**NSLPP MEETING HELD ON 3/11/2021****Attachments:**

ADDRESS/WARD: 35 Bay View Street, Lavender Bay**APPLICATION No:** DA 211/21**PROPOSAL:** Substantial alterations and additions to a dwelling house including a new attic level and double garage.**PLANS REF:**

OWNER: Henry Cheung**APPLICANT:** Bronwyn Litera**AUTHOR:** Sophie Griffiths, Student Town Planner**DATE OF REPORT:** 15 October 2021**DATE LODGED:** 9 July 2021**AMENDED:** 1 October 2021**RECOMMENDATION:** Approval

Figure 3: Extract of long section Diagram (source: GSA Planning, Clause 4.6 Exception to a Development Standard.

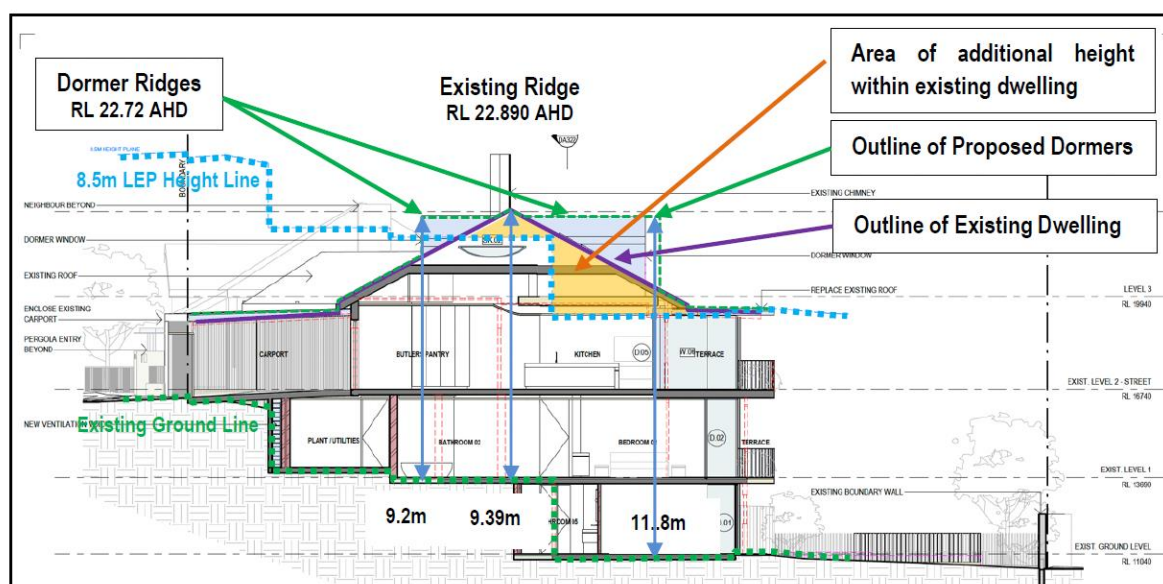
The proposed works would have a maximum height of 11.8m that fails to comply with the permissible height limit of 8.5m in accordance with Clause 4.3 in NSLEP 2013. It is noted that the proposal will retain the existing maximum ridge height. The reconfigured dwelling will have a building height of 11.8m with both the proposed dormers above the 8.5m height control. The remainder of the proposed works are compliant with the maximum height control. All proposed works are below the existing ridge of the dwelling.

Figure 1: Streetscape Elevation showing Reduced and Altered Dormer

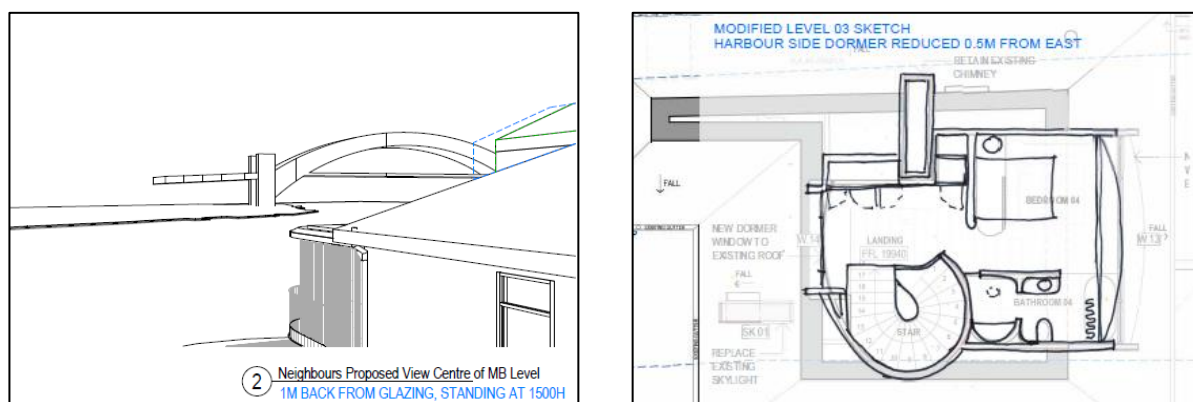
The front dormer has been adjusted to increase the roof pitch and reduce the width, which results in a form which is considered sympathetic to the streetscape and suits the dwelling form (see **Figure 1**). This amended form is supported by the Heritage Advisor, Zoltan Kovacs.

Figure 6: Adjusted Suspended Walkway

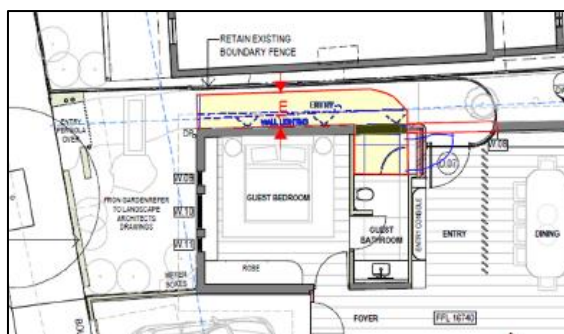
LTA have reduced the length of the elevated walkway and splayed the entry to the dwelling, which provides an angled entry to the dwelling. The width is also reduced to one metre clear, which is setback to the common boundary (see **Figure 6**). This reduces slightly the adjacent en-suite. We note that the neighbours' architect had proposed a reduction in the length of the walkway, and that our amended proposal depicts an equivalent reduction. Again, when this was submitted, it was on the assumption it was adjacent to a blank wall.

Figure 8: Partially Solid and Partially Open Side Fence adjacent to Lowered Deck

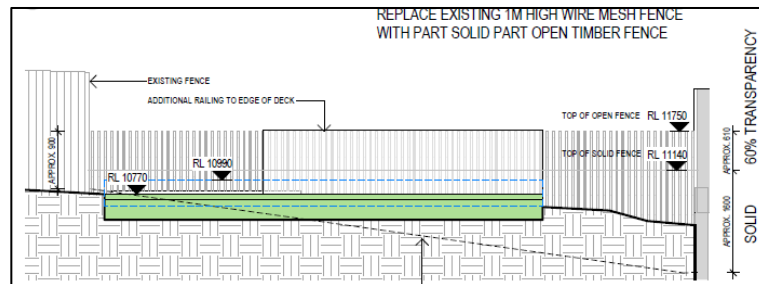
LTA have prepared drawings showing the deck area lowered (by 220mm) and repositioned further south, with a balustrade and planter for greater separation. Additionally, a timber lapped and capped boundary fence to 1600mm high is proposed, with timber slats extended above to 600mm high, as a lattice equivalent (see **Figure 8** on the following page).

The lowered ground level adjacent to the boundary would include planting for a further buffer. The drawings show a shallow viewing angle which would extend across the site, rather than downwards into the adjacent garden. This is considered an improvement on the existing wire fence and passionfruit vine, which provides only limited privacy.
